DESIGN DS	DRAWN BY DS	DART AEROSPACE LTD HAWKESBURY, ONTARIO, CANADA	
CHECKED <i>[Signature]</i>	APPROVED <i>[Signature]</i>	DRAWING NO. DEO 9153	REV. A SHEET 1 OF 1
DATE 99.04.26		TITLE 206 SKIDTUBE TOW RING BOLT	SCALE NTS
A	99.04.26	NEW ISSUE

DART ENGINEERING ORDER

TO AMEND DRAWING D2650 REV. C

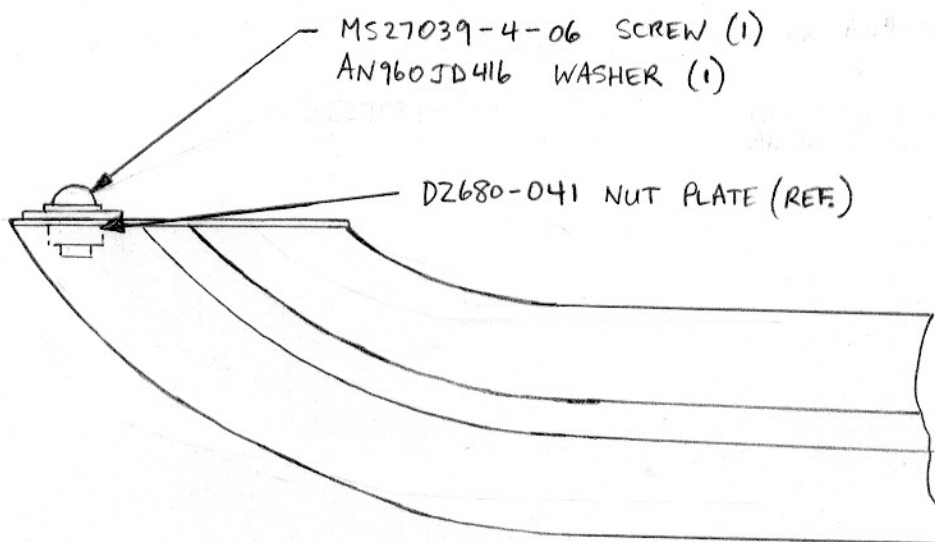
INSTALL MS27039-4-06 SCREW IN D2680-041 NUT PLATE
LOCATED ON FWD END OF D2650-1/-3/-5/-7 SKIDTUBE ASSEMBLIES.
SEAL WITH SIKAFLEX 241/291 SEALANT.

NOTE: AN4-3A BOLT CAN BE SUBSTITUTED FOR MS27039-4-06 SCREW
IF MS27039-4-06 ARE UNAVAILABLE.
